UNITED STATES  
NUCLEAR REGULATORY COMMISSION  
WASHINGTON, D. C. 20555

DONALD C. COOK NUCLEAR PLANT, UNIT NO. 1

AMENDMENT TO FACILITY OPERATING LICENSE

Amendment No. 136  
License No. DPR-58

Figure 5.6-1: Donald C. Cook Nuclear Plant Schematic for Fuel Storage Racks Interface Boundary Between Regions 1 and 2

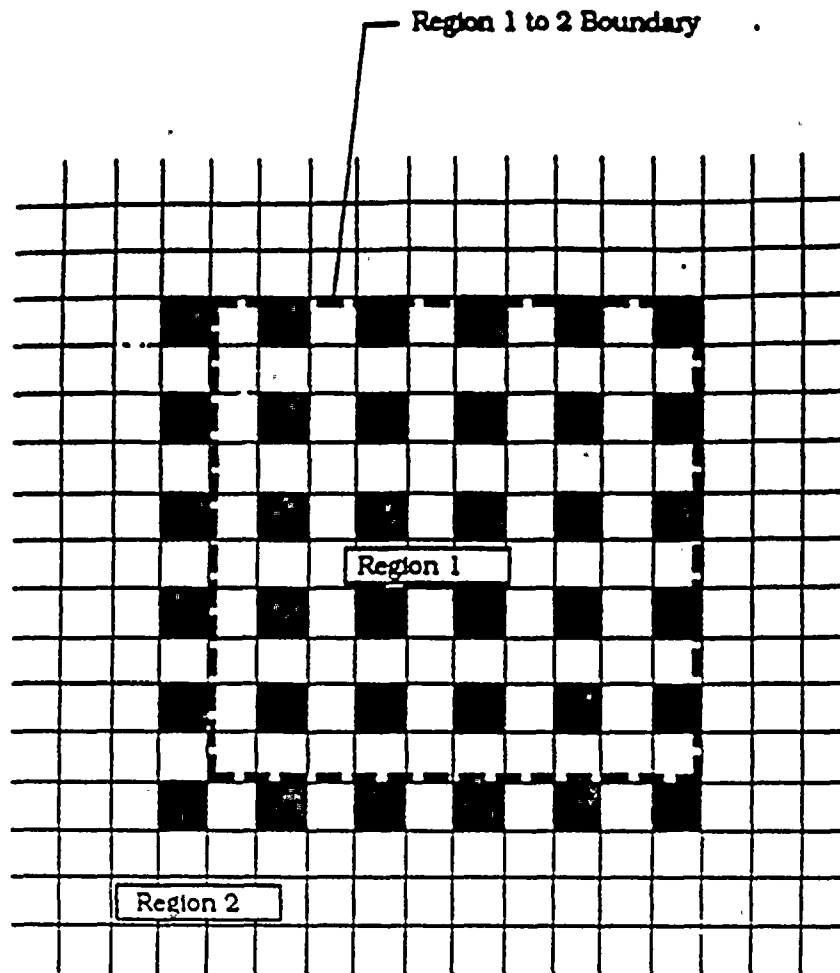
- a. A  $k_{eff}$  equivalent to less than 0.95 when flooded with unborated water,
- b. A nominal 10.5 inch center-to-center distance between fuel assemblies placed in the storage racks.
- c. 1. A separate region within the spent fuel storage racks (defined as Region 1) shall be established for storage of Westinghouse fuel with nominal enrichment above 3.95 weight percent U-235 and with burnup less than 5,550 MWD/MTU. In Region 1, fuel shall be stored in a three-out-of-four cell configuration with one symmetric cell location of each 2 x 2 cell array vacant.  
2. The boundary between the Region 1 mentioned above and the rest of the spent fuel storage racks (defined as Region 2) shall be such that the three-out-of-four storage requirement shall be carried into Region 2 by, at least, one row as shown in Figure 5.6-1.

Figure 5.6-1: Donald C. Cook Nuclear Plant Schematic for Fuel Storage Racks Interface Boundary Between Regions 1 and 2

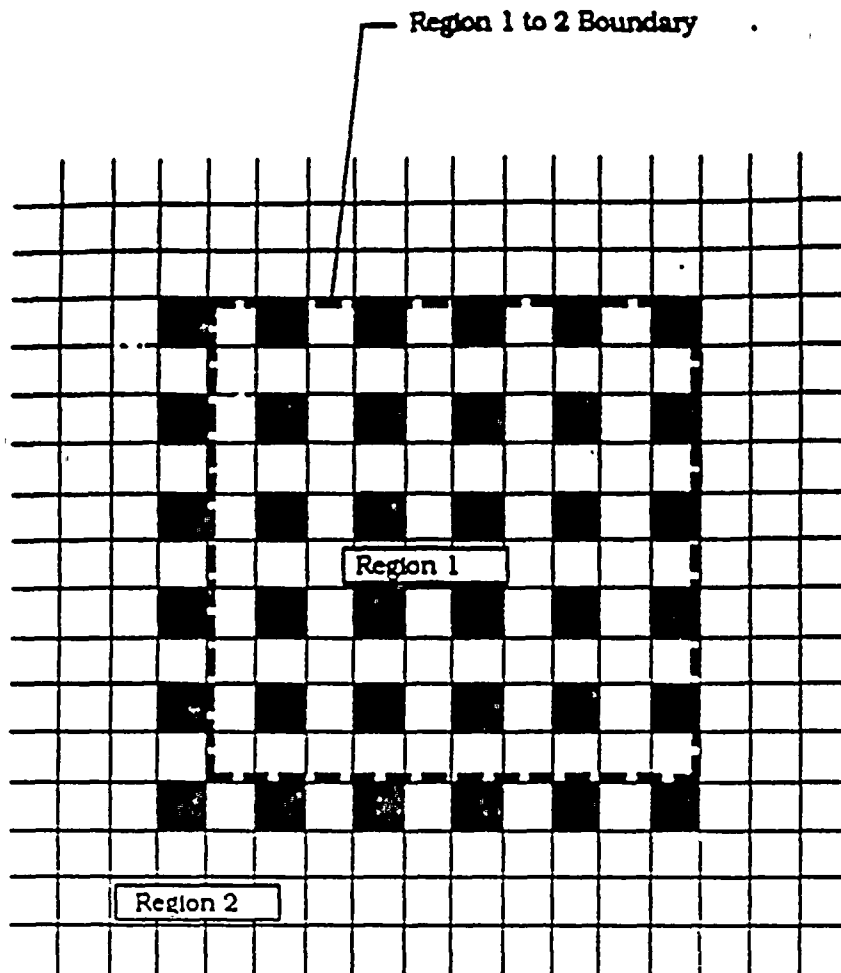
- a. A  $K_{eff}$  equivalent to less than 0.95 when flooded with unborated water,
- b. A nominal 10.5-inch center-to-center distance between fuel assemblies, placed in the storage racks.
- c. 1. A separate region within the spent fuel storage racks (defined as Region 1) shall be established for storage of Westinghouse fuel with nominal enrichment above 3.95 weight percent U-235 and with burnup less than 5,550 MWD/MTU. In Region 1, fuel shall be stored in a three-out-of-four cell configuration with one symmetric cell location of each 2 x 2 cell array vacant.  
2. The boundary between the Region 1 mentioned above and the rest of the spent fuel storage racks (defined as Region 2) shall be such that the three-out-of-four storage requirement shall be carried into Region 2 by, at least, one row as shown in Figure 5.6-1.
